NUMBER: 23-002-13

Rattle And/Or Clunking Sound From Convertible Top

2011-2012 (JS) Chrysler 200

Fig. 2 Down Capture Receiver Rod Replacement

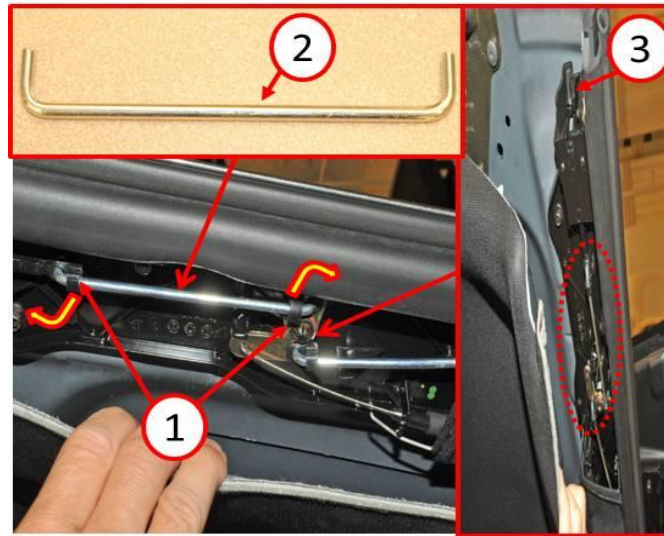
- a. Yes >>> Proceed to [Step #3](#).
 - b. No >>> Proceed to [Step #4](#).
3. Replace the damaged or bent receiver rod(s) by swinging the retaining clips open and pulling the rod out of the clips ([Fig. 2](#)).

Fig. 4 Side Rail Down Capture Hook Replacement

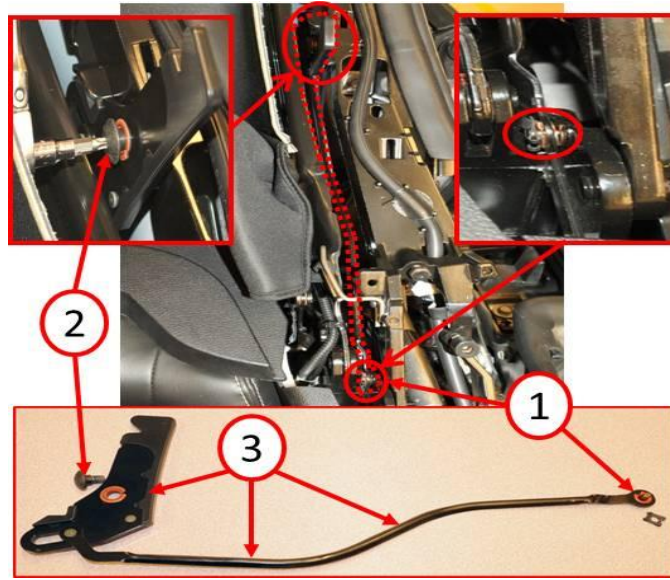
-
5. Remove the push clip retainer and pin clevis (1) along with the torx shoulder bolt (2) (Fig. 4) to replace the side rail down capture hook assembly with the appropriate side/color specific revised part indicated in the parts section.
